LRN-02-0394

**REQUEST FOR ADDITIONAL INFORMATION  
INSERVICE INSPECTION PROGRAM RELIEF REQUEST  
S1-RR-B01  
SALEM GENERATING STATION- UNIT 1  
FACILITY OPERATING LICENSE DPR-70  
DOCKET NOS. 50-272**

Pressurizer Relief  
and  
Pressurizer Spray Lines  
Nozzle  
to  
Safe-end  
Weld Configurations

Weld Configurations

TITLE: 6-IN SCH. 160 SAFETY & RELIEF NOZ. (CAST TYPE)

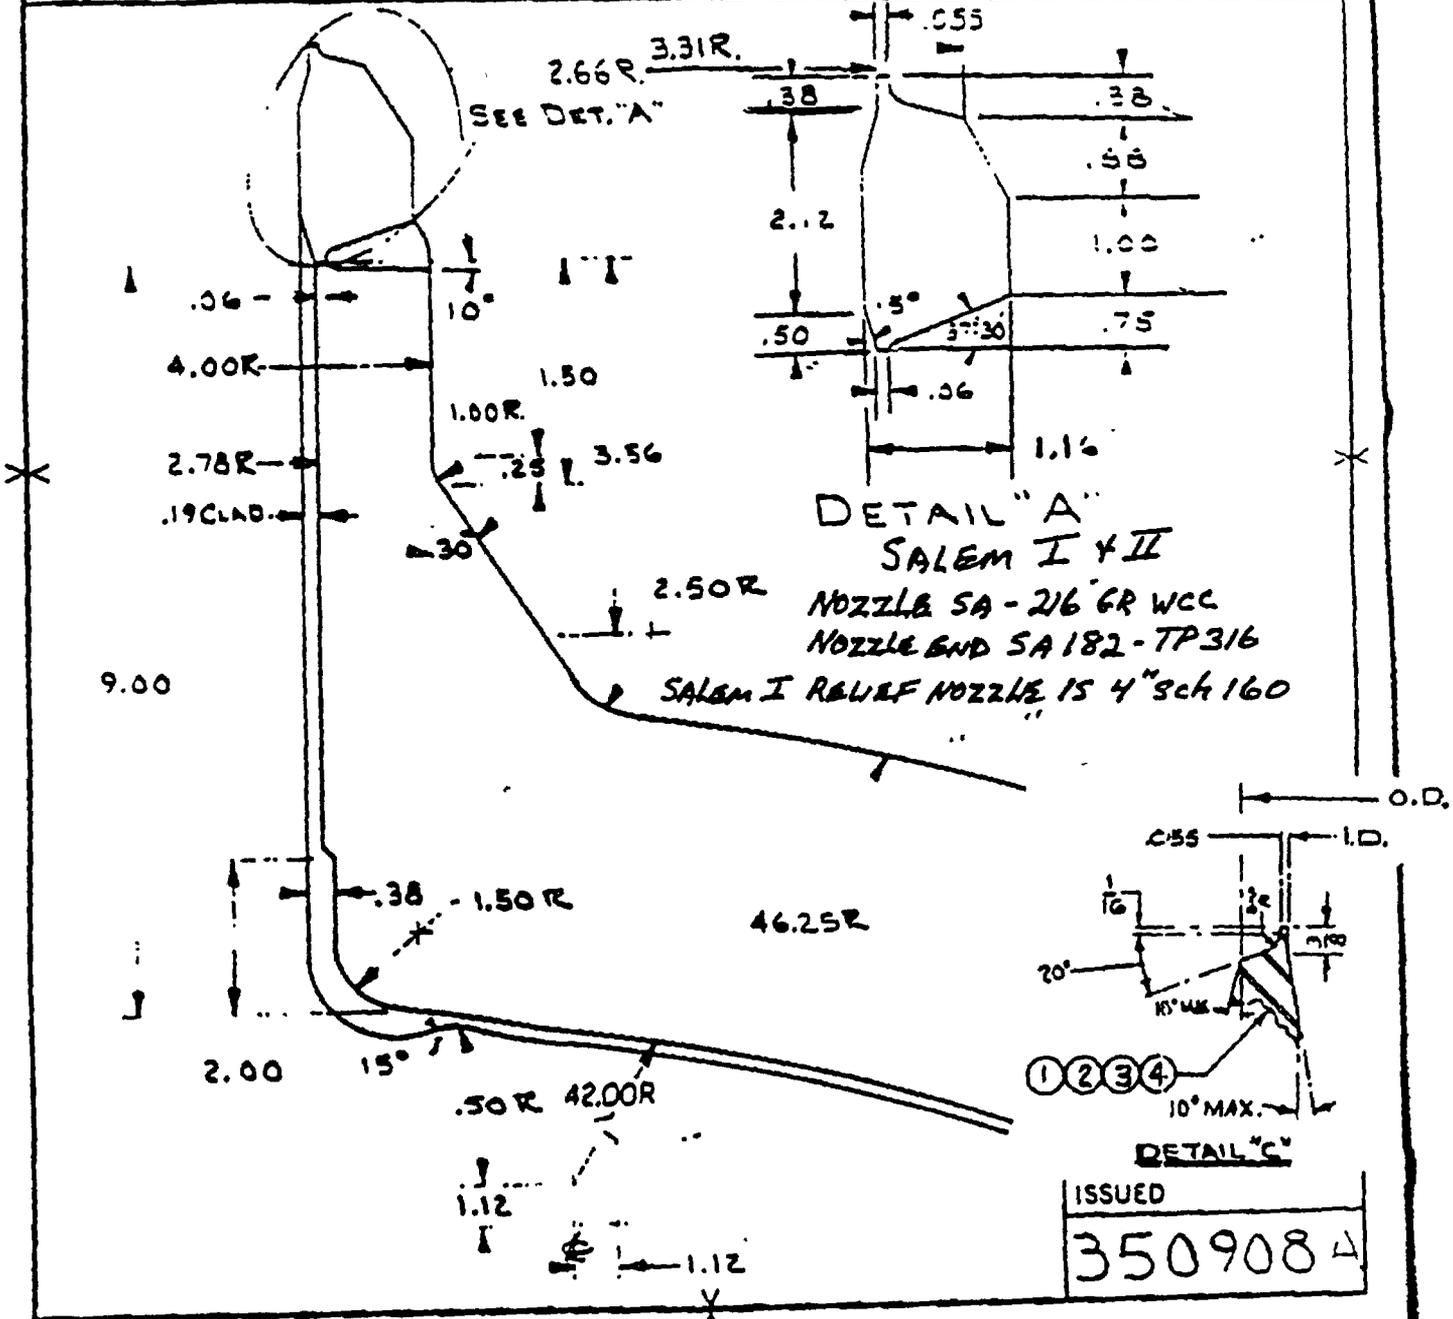
The Pressurizer relief and spray line 'nozzle to safe-end' welds 6-PR-1104-1 (Summary No. 023400), 6-PR-1103-1 (Summary No. 024600), 4-PS-1131-29 (Summary No. 033500) and 4-PR-1100-1 (Summary No. 025900) do not contain Alloy 600 type material as evidenced by Attachment 1 drawing and information.

# SALEM I S/G REPLACEMENT PRIMARY NOZZLE W 4 LOOP MODEL "F"

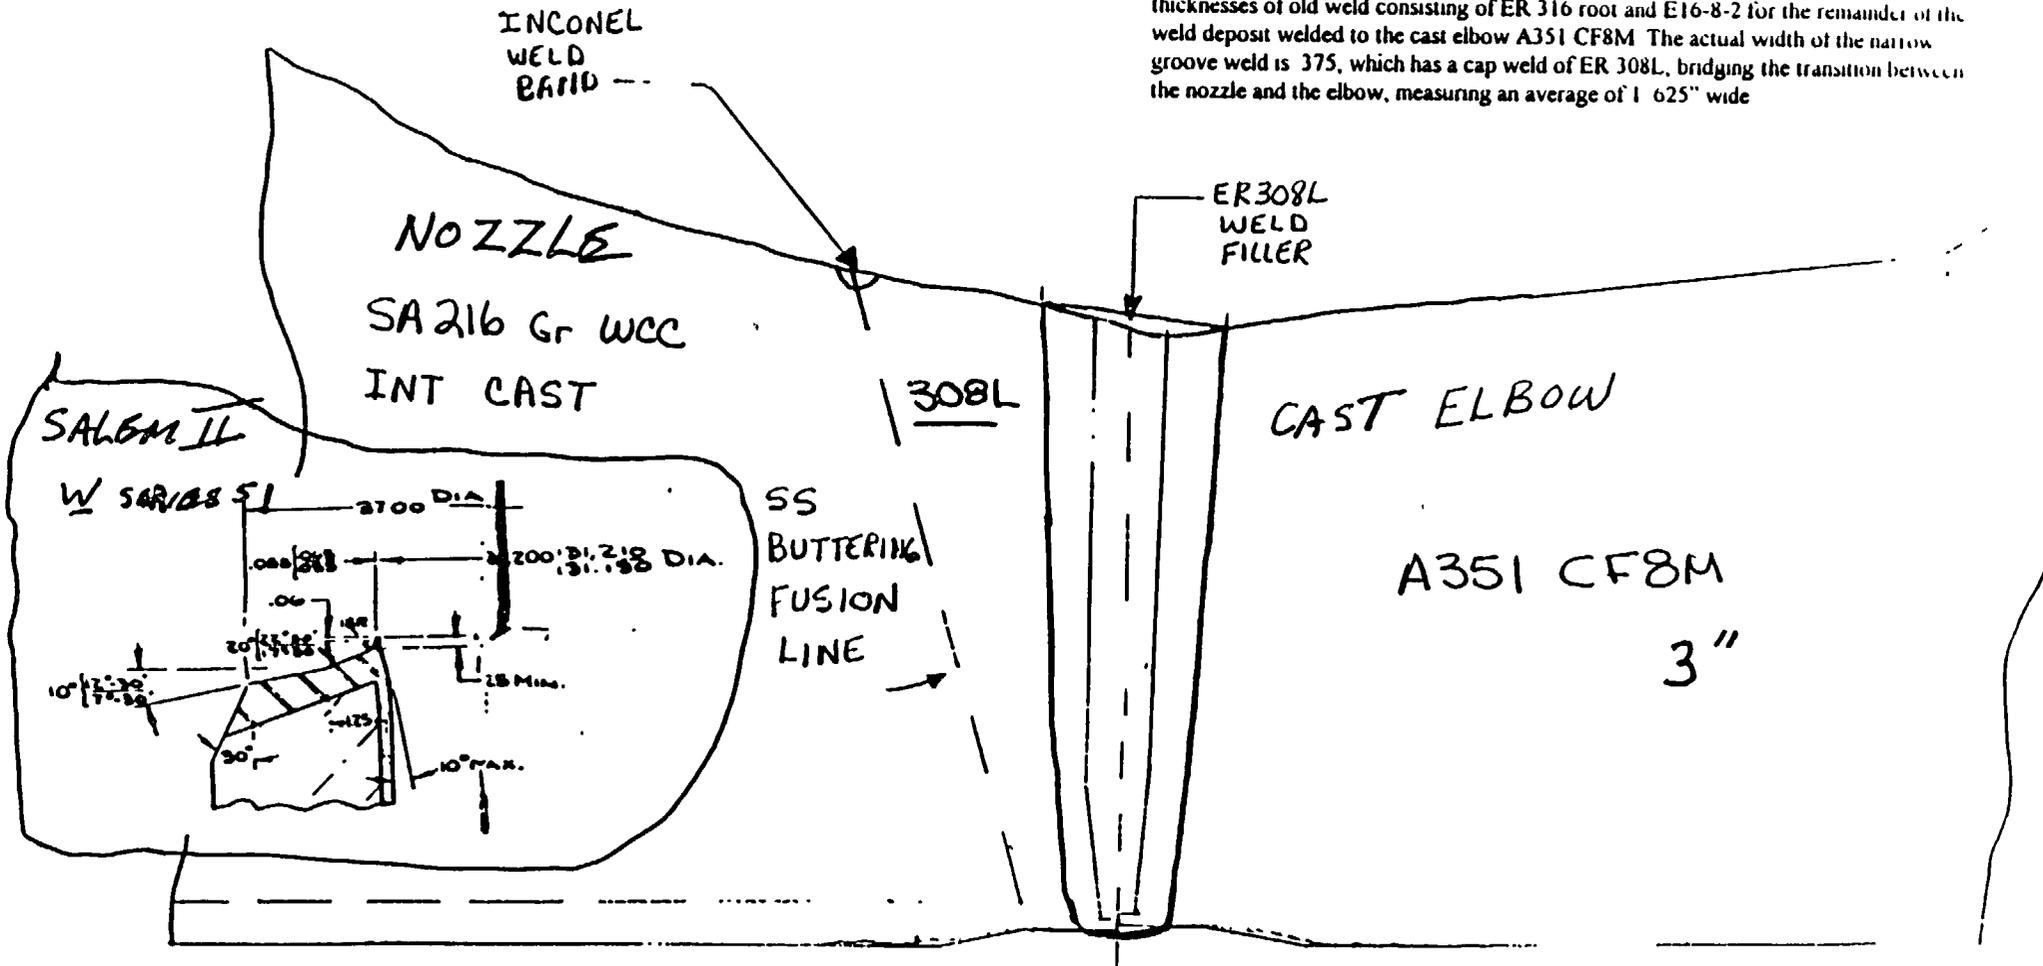
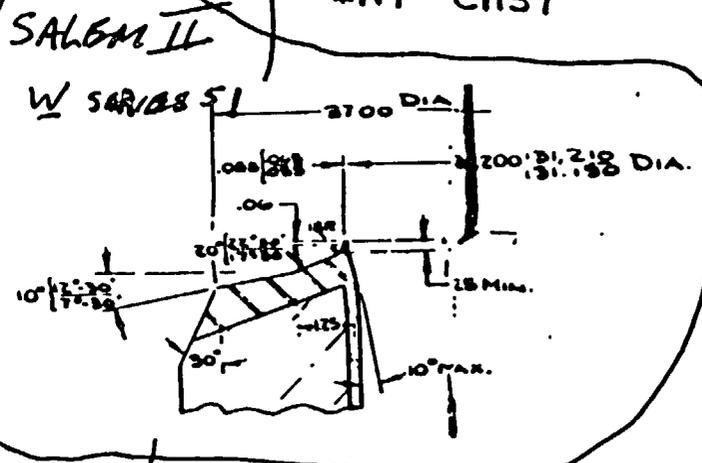
The Steam Generator nozzle-to-elbow welds 31-RC-1130-2R1 (Summary No. 039200), 29-RC-1130-5R1 (Summary No. 050210), and 29-RC-1120-5R1 (052600) contain a single bead of Alloy 600 material located on the outside of the pipe. The Alloy 600 material is not in contact with the primary reactor water coolant located on the inside of the piping as evidenced by Attachment 2 drawing and information.

The new welds consists of SA 216 Gr WCC cast nozzle, Inconel weld band 308L old weld from the hydro cap welded at Seabrook, 308L narrow groove weld, various thicknesses of old weld consisting of ER 316 root and E16-8-2 for the remainder of the weld deposit welded to the cast elbow A351 CF8M. The actual width of the narrow groove weld is .375, which has a cap weld of ER 308L, bridging the transition between the nozzle and the elbow, measuring an average of 1.625" wide

Original welds for OSBs  
ER 316 for first 3/8"  
E16-8-2 for the remainder  
of the weld deposits  
Equivalent to P-No 8 Materials
